**CITY OF BATON ROUGE
PARISH OF EAST BATON ROUGE**

ADDENDUM NO. 2

**SUBJECT: OLD HAMMOND HIGHWAY – SEGMENT 1
S. FLANNERY TO GOODWOOD**

CITY-PARISH PROJECT No. 12-CS-HC-0043A-4

SHEET NUMBER	7
PARRISH	EAST BATON ROUGE
CITY	12-CS-HC-0043A
PROJECT	
STATE	LA
PROJECT	
FORMED	MJK
CHECKED	CAB
DETAILED	JBC
CHECKED	CAB
DATE	12-07-2023
SHEET	4 of 4
REVISED ITEM NUMBER	MJK
REVISED TEMP. LANE SECTION DETAIL	JBC
REVISION DESCRIPTION	BY
DATE	DATE
NO.	NO.

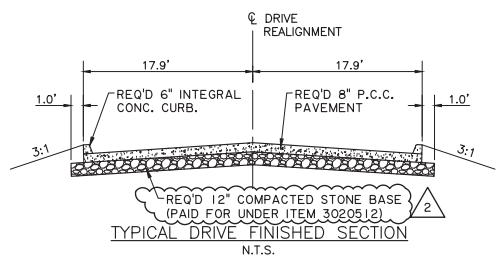
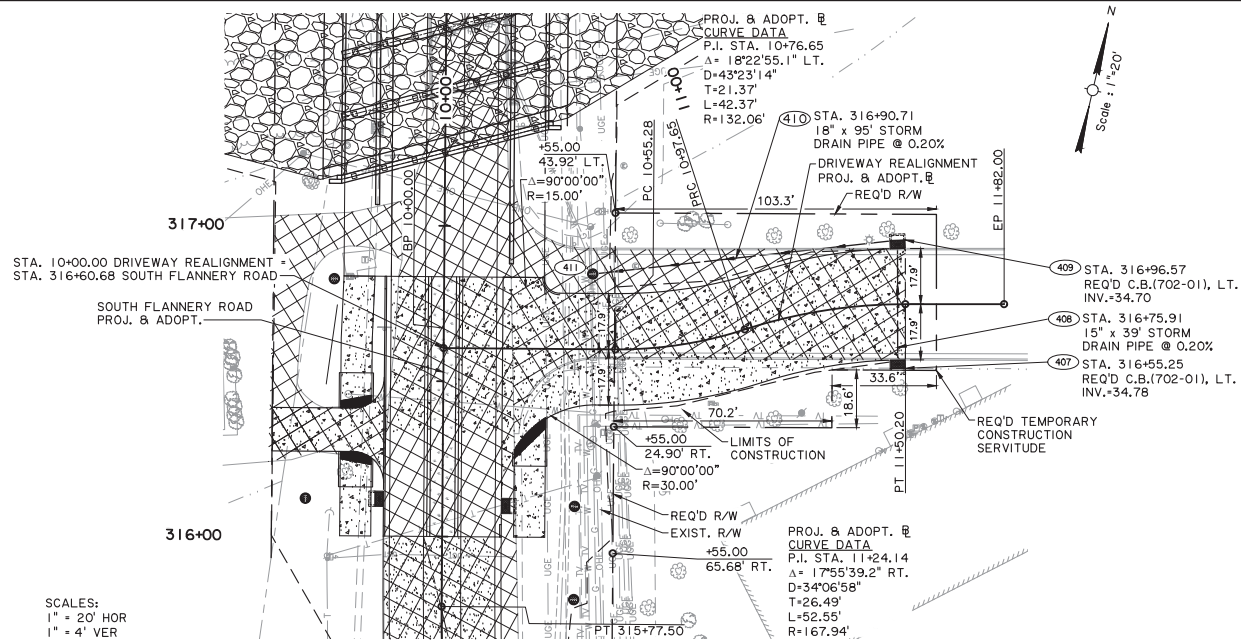
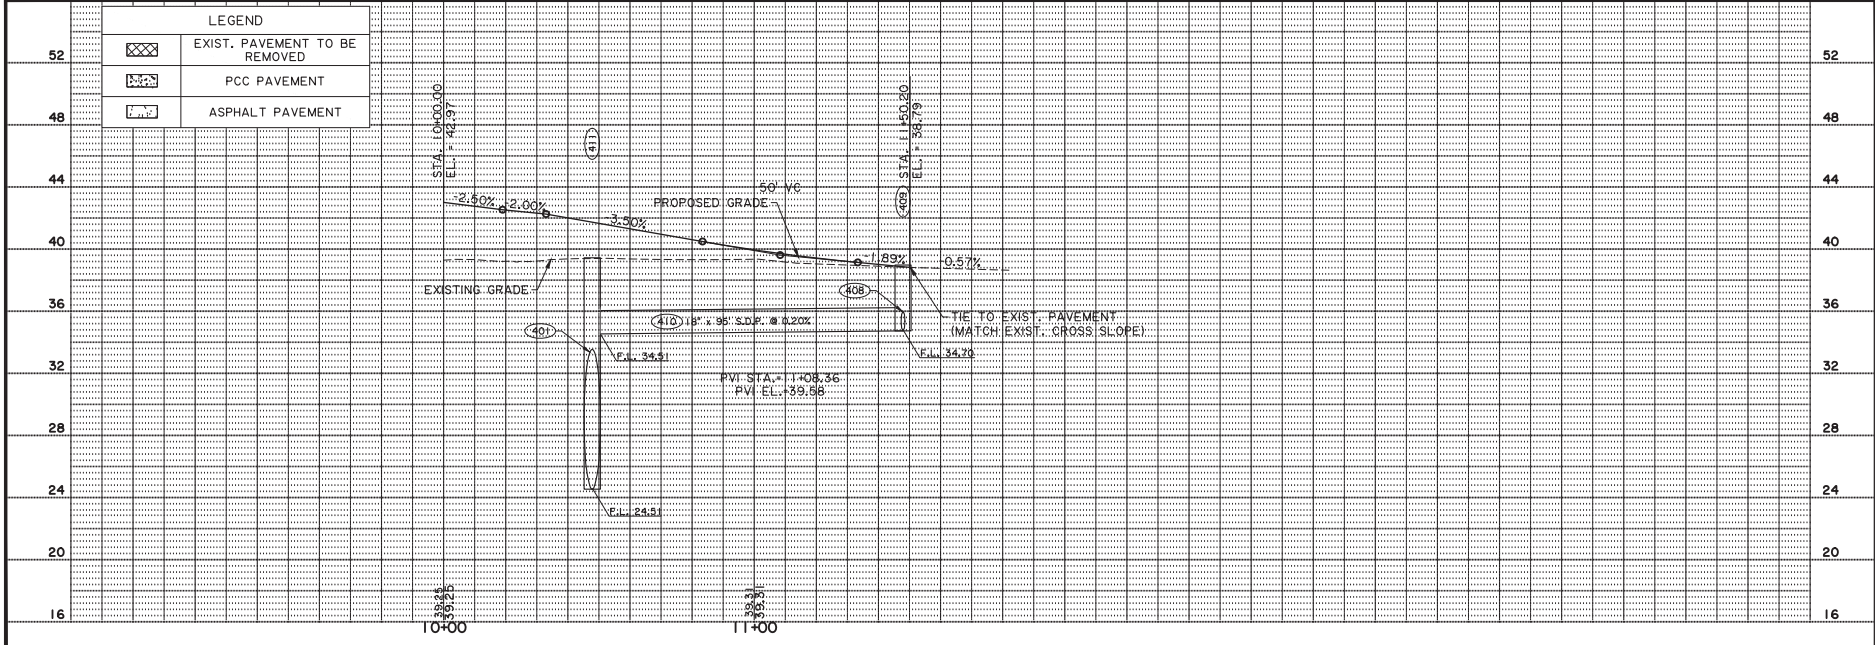
Sheet 7 says to pay compacted stone base under item 3030412. That is Type D Subgrade...Is that correct?

Sheet 7 note has been revised and Pay Item 3020512 Stone Base Course (12" Thick) has been added.
